PROJECT TITLE: SANTA FE VILLAGE ZONE ATLAS/DRNG. FILE #: E10/D8DRB #: _____ EPC #: _____ WORK ORDER #: 3116.90LEGAL DESCRIPTION: SANTA FE VILLAGE, UNIT 1CITY ADDRESS: NAENGINEERING FIRM: BORDENAVE DESIGNS CONTACT: J. BORDENAVEADDRESS: P.O. Box 91194, 87199 PHONE: 823-1344OWNER: SMC PROPERTIES, INC. CONTACT: S. ThompsonADDRESS: P.O. Box 11519, 87192 PHONE: 291-3715

RE: GRADING & EROSION CONTROL PLAN SUBMITTAL OF SANTA FE VILLAGE
UNIT I, PHASE V, RECEIVED FEBRUARY 4, 1987 FOR ROUGH GRADING
PERMIT APPROVAL (E-10/D3)

RE: DRAINAGE REPORT SUBMITTAL OF SANTA FE VILLAGE UNIT I PHASE V,
RECEIVED NOVEMBER 14, 1986 FOR PRELIMINARY PLAT AND ROUGH
GRADING PERMIT APPROVAL (E-10/D3)

RE: DRAINAGE REPORT SUBMITTAL OF SANTA FE VILLAGE, UNIT I
RECEIVED FEBRUARY 25, 1986 FOR PRELIMINARY PLAT APPROVAL
(E-10/D3)

CITY OF ALBUQUERQUE MUNICIPAL DEVELOPMENT DEPARTMENT ENGINEERING DIVISION					
TITLE: SANTA FE VILLAGE UNIT I PHASE V GRADING PLAN & EROSION CONTROL PLAN					
APPROVALS	ENGINEER	DATE	APPROVALS	ENGINEER	DATE
DRAWING NO. 3116		MAP NO. F-10		SHEET 3 OF 11

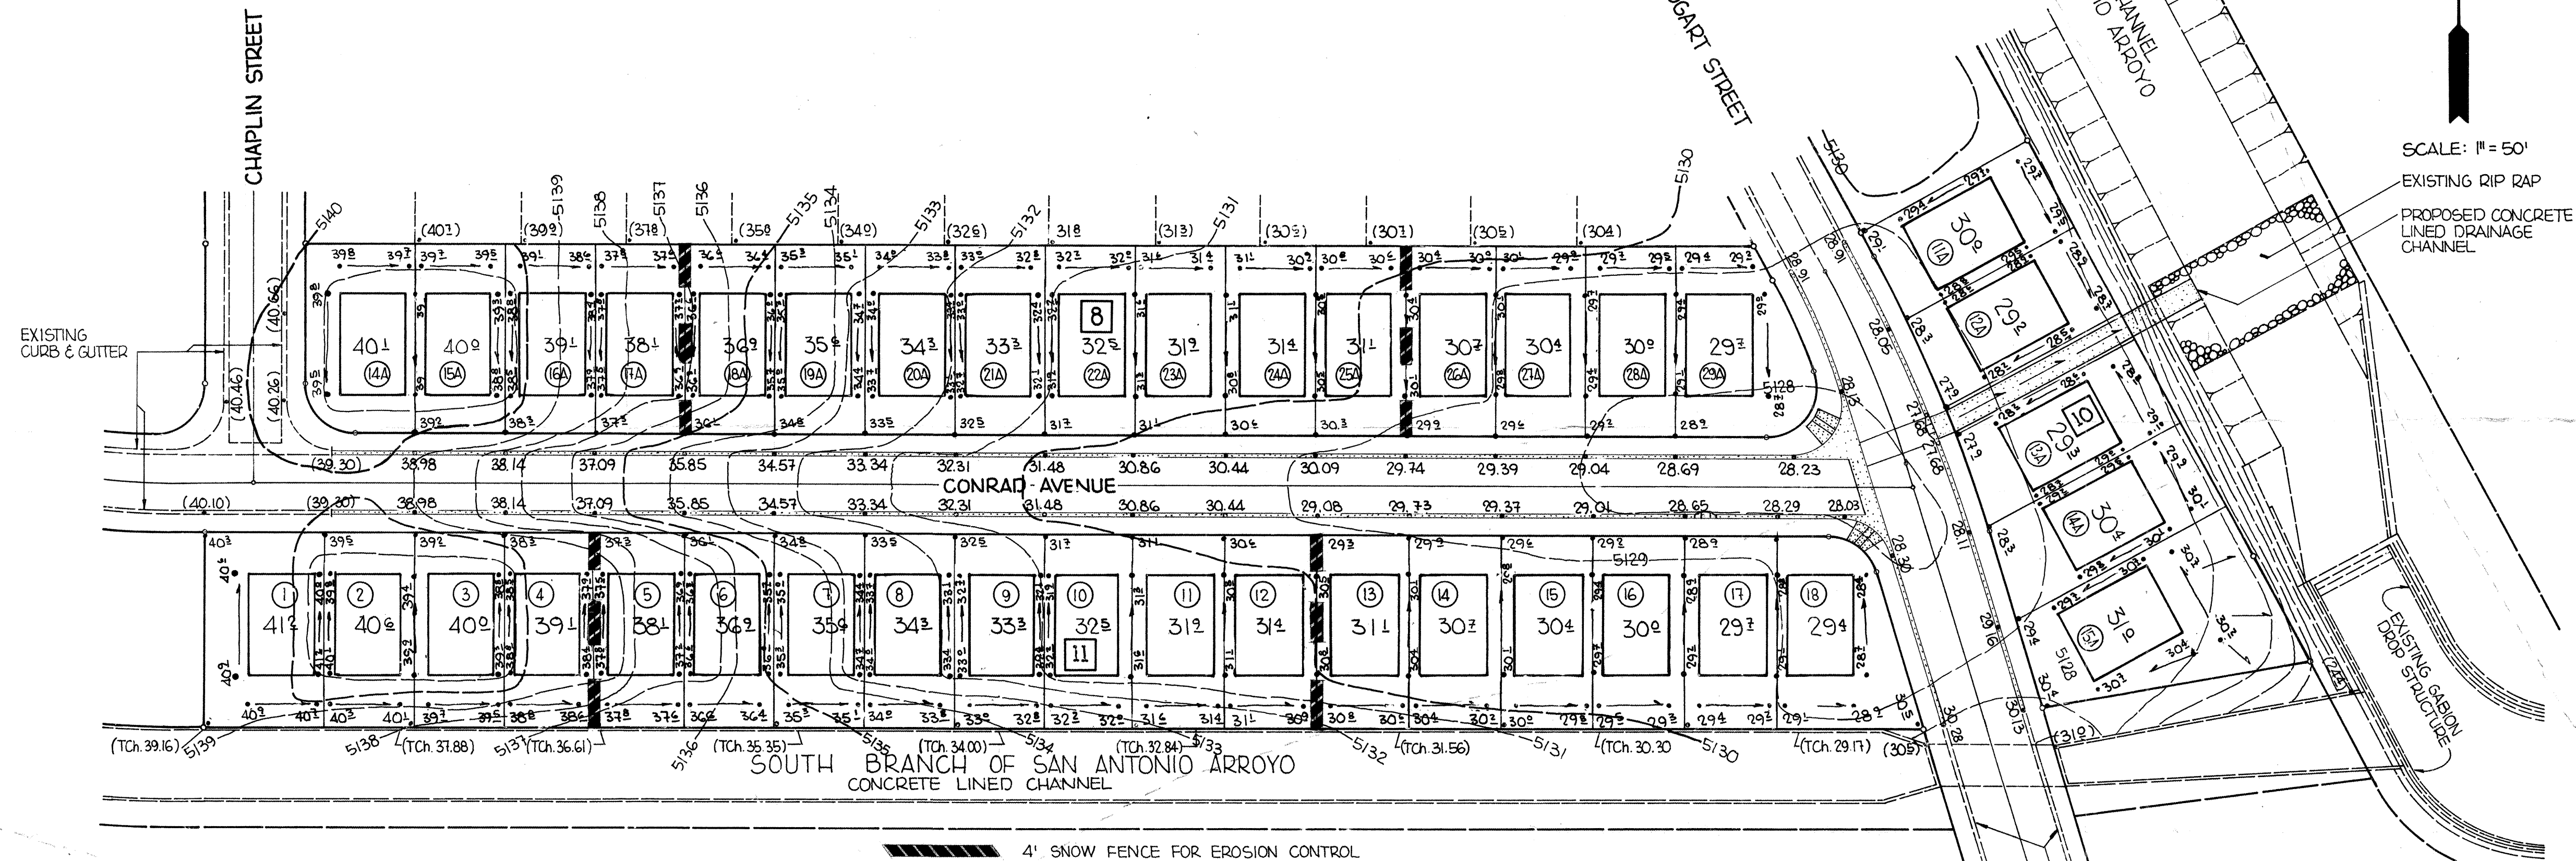
This approval does not constitute any approval of proposed street grades, since this is done at the DRC. I also recommend that the Drainage R.O.W. width for the concrete rundown between Lots 12A and 13A be eleven feet to be consistent with the structure width.
